IP-4d

Version 1.07-rc2

23.04.2026

IP-4d Release Candidate Notes

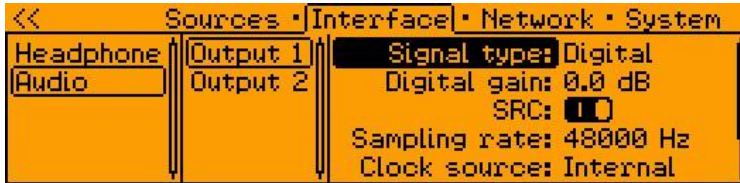
- Added audio output configuration to the LCD menu

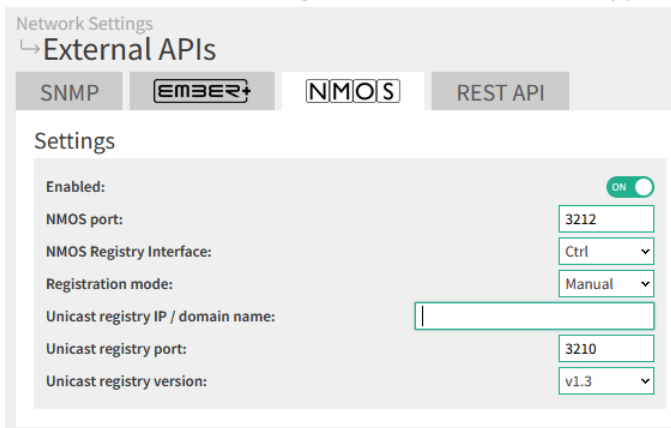
- The NMOS implementation was updated and enhanced. Besides the already existing support for IS-05 (Device Connection Management) we do now also support IS-04 (Discovery & Registration).

In addition to the manual registration mode the registration can also be done via mDNS and DHCP.

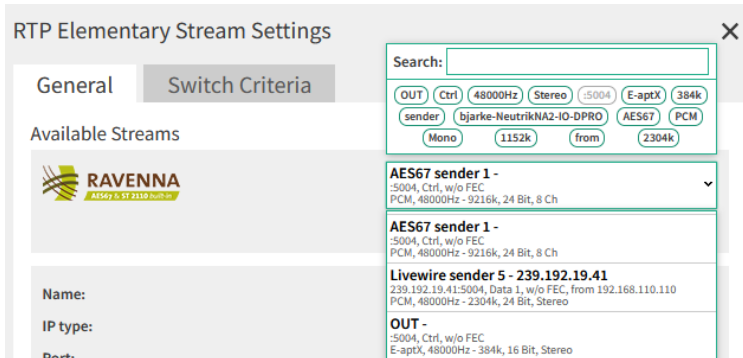
- The list of available Ravenna streams may get long. Now we've added the possibility to filter the list by a freely entered text or by automatically generated tags

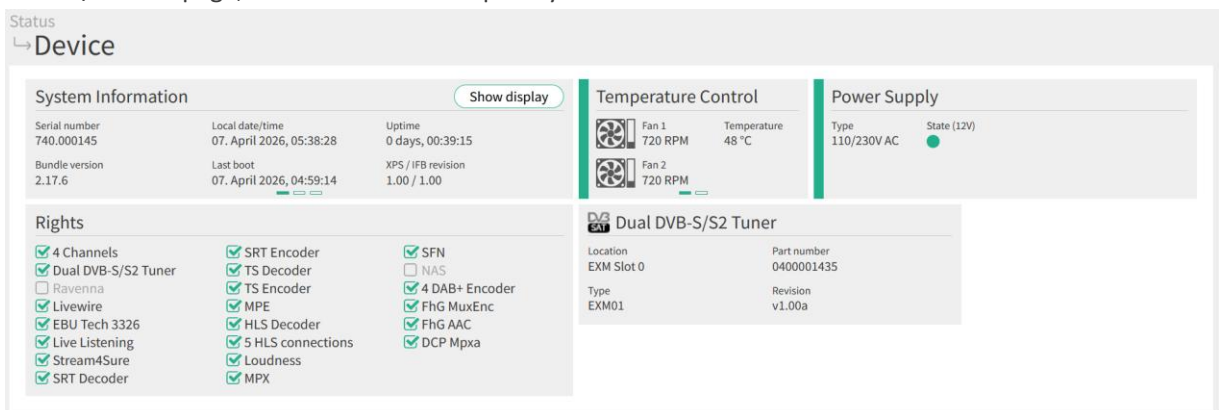
- The System Information, which was formerly found under System Settings / Global, has been moved to the Status / Device page, which has been completely revised

The System Settings / Global page looks therefore of course different now, too:
